RE: Compliance Extension Request

RE: **EM-SPRINT-069-130409** – Sprint Spectrum L.P. notice of intent to modify an existing telecommunications facility located at 246 East Franklin Street, Killingly, Connecticut.

Structural Analysis for SBA Network Services, Inc.

MODIFICATION DRAWINGS FOR A 155' MONOPOLE

S-2

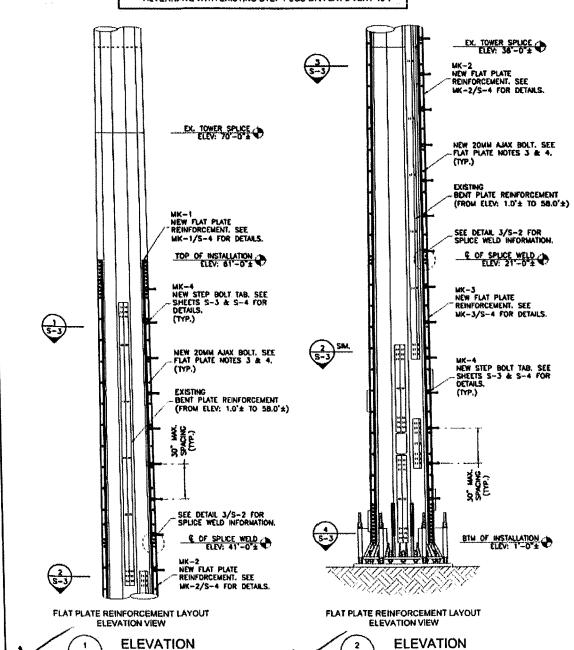
OV VY LOCATIONS CORRECT.

CONTRACTOR TO INSTALL NEW STEP PEGS SUCH THAT THEY ALTERNATE WITH EXISTING STEP PEGS ON FLAT 2 VERY 15".

SHEET NUMBER S-2

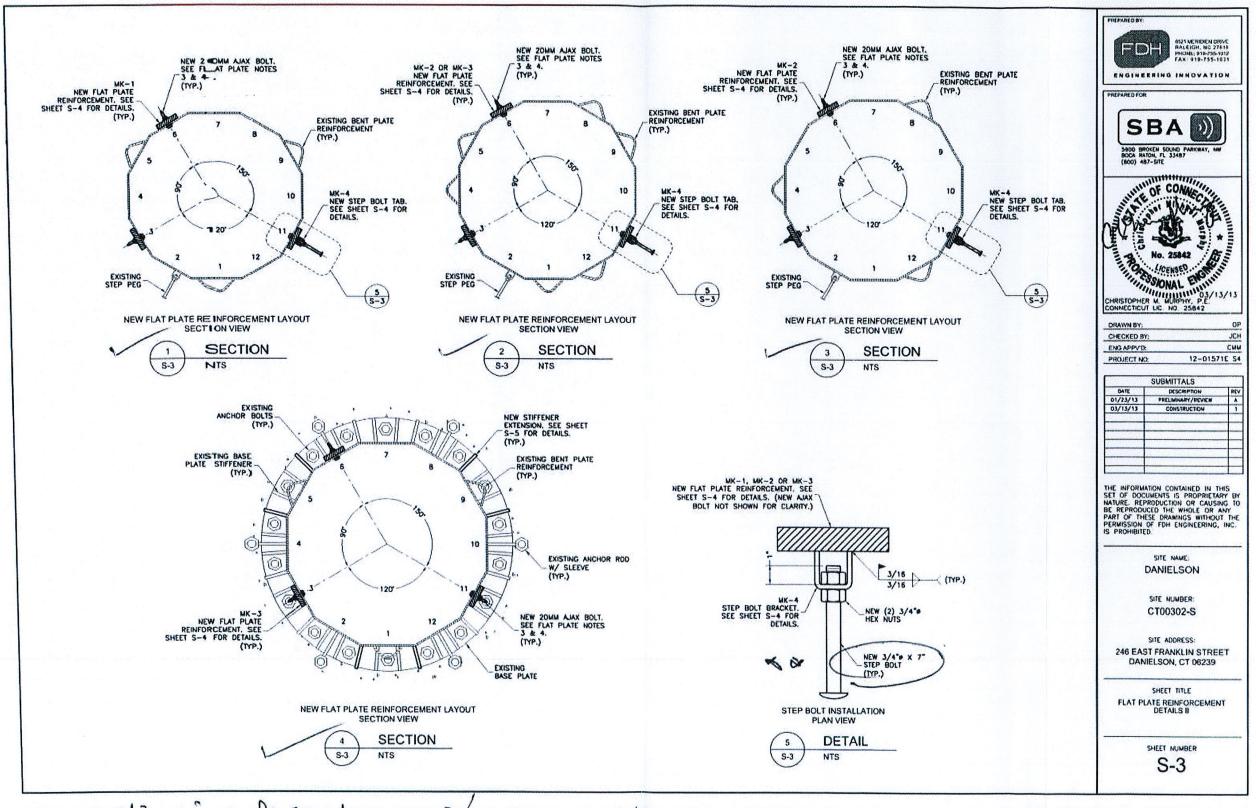
XX Climbing PLGS ARL 6.5 / NOT 7 AS PLANS SHOW.

- Bryce called out that the step pegs are 6.5" and not 7". I doubt this will be an issue Should be fine.
- Small area of rust/grind on flat plate very minor
- He calls out a weld issue, but if it passes CWI, then no worries Will review with CWI.

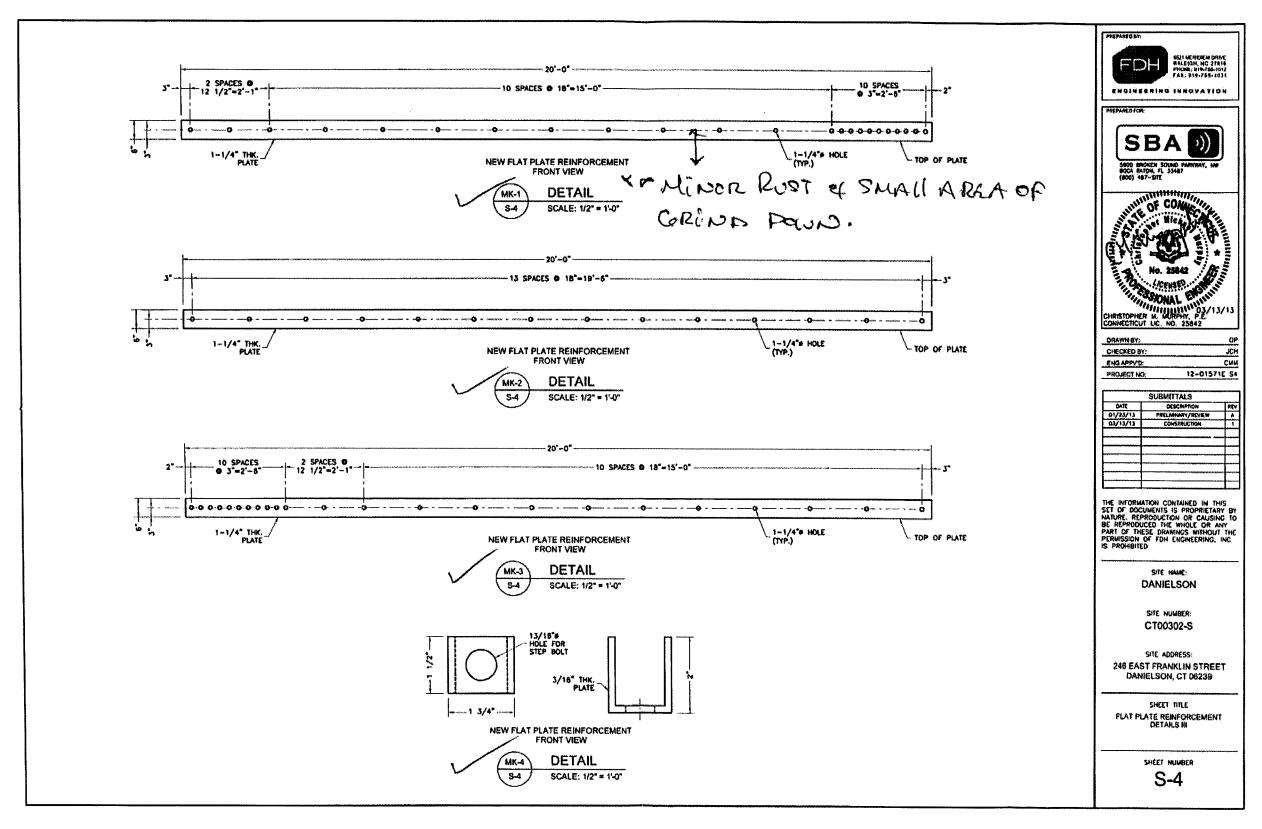
XX CONTRACTOR LEFT SKUKRAL RUCHUD STRAL FROM INSTALLING FLAT PLATE & AJAX BOLLS INSIDATHE MONDPOLA.

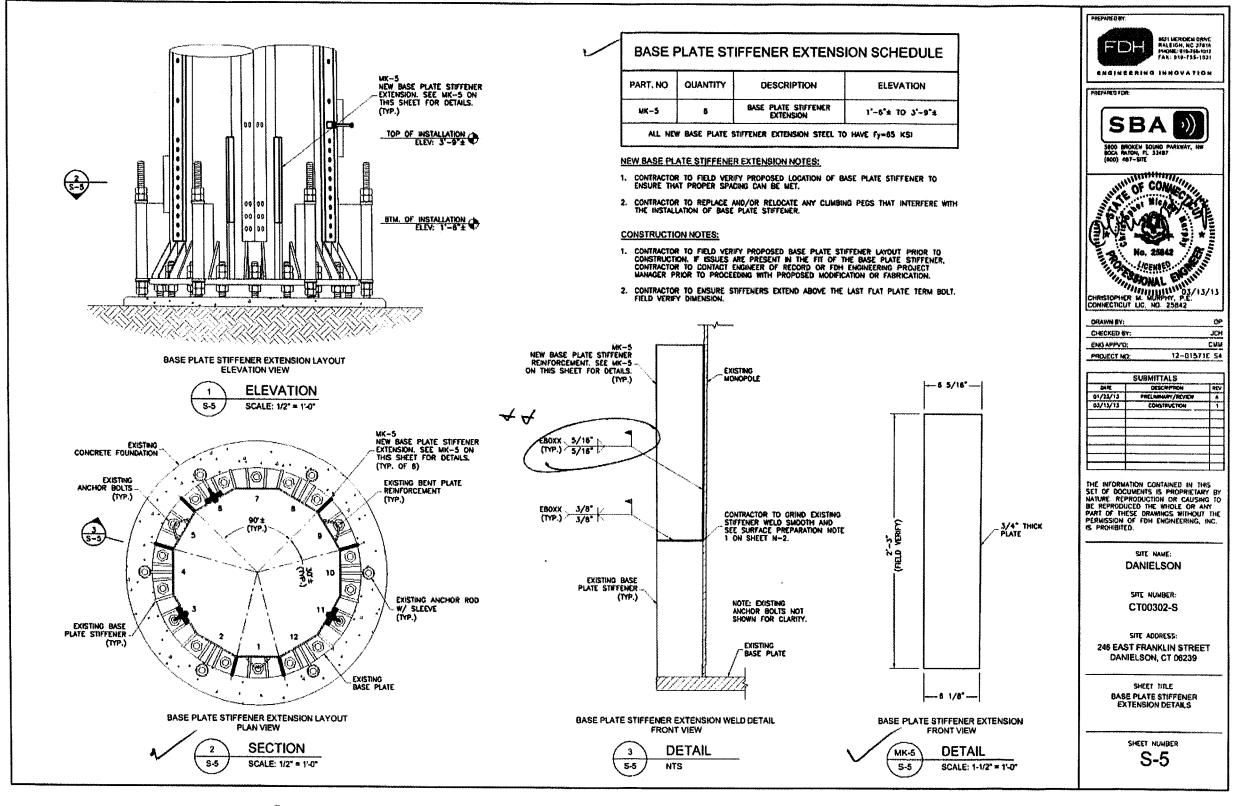
XX FOUR ARKAS OF WELDS WHERE IT DORSN'T QUITE COME OUT 5/16.
